MCPB Item No.

B. Mandatory Referral No.2013025: Clarksburg/Damascus Middle School No.2

Staff Recommendations: Approval and Transmit Comments to Montgomery County Public Schools (MCPS)

Proposed Site Plan

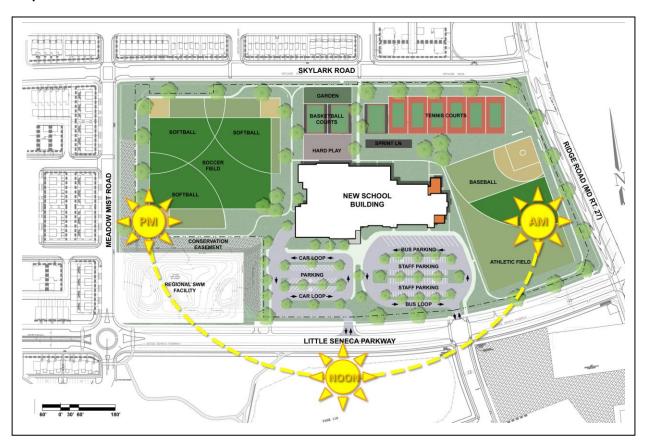
The site plan includes two driveways on the south of the site from Little Seneca Parkway to the School's two parking lots. There are two school entry and exit points, one per parking lot. The proposed parking lot entry and exit points do not conflict with the surrounding residential development.

Parking

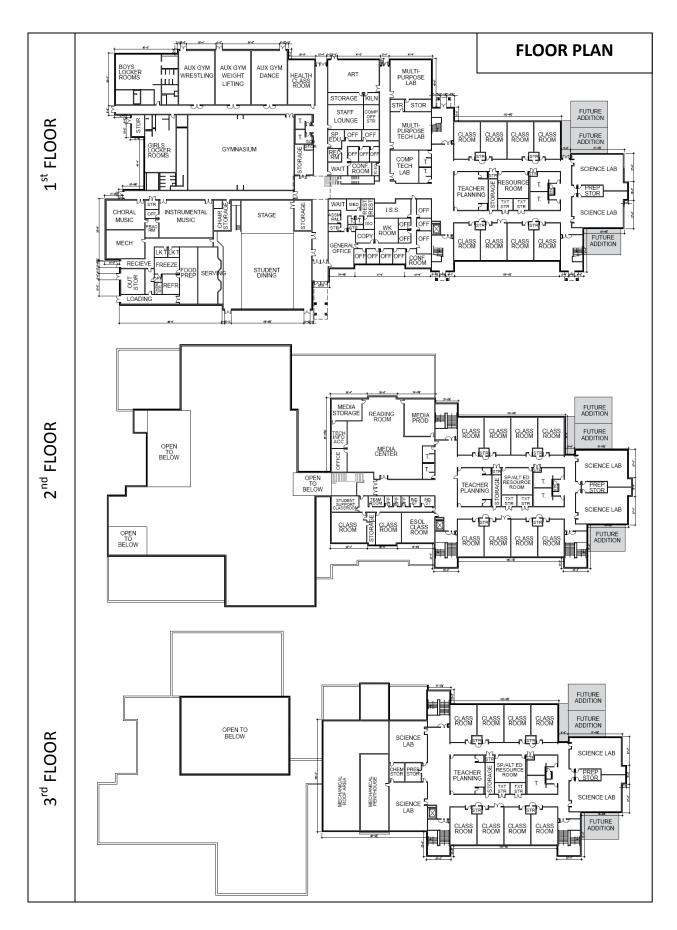
South of the proposed buildings are two separate surface parking lots that will accommodate the parking needs and future growth. Both lots will be accessed from Little Seneca Parkway on the south side, central to the site. The two parking lots will adequately and safely accommodate 130 vehicles, including six ADA compliant handicap spots, a bus loop, 16 diagonal bus parking spots, and a loop to the student drop-off area.

All required parking is located in two separate surface parking lots in the center of the site, south of the building. The parking lots include approximately 130 parking spaces, six of which are ADA compliant spots. The west parking lot includes a counterclockwise loop and student drop off area, surrounding 41 diagonal parking spots. The east parking lot includes a counterclockwise loop, bus parking and drop off area, with staff parking in the center. Staff arrives prior to bus arrival in the morning and leave after bus departure in the afternoon, thus locating staff parking in the center of the bus loop will minimize the potential for collision.
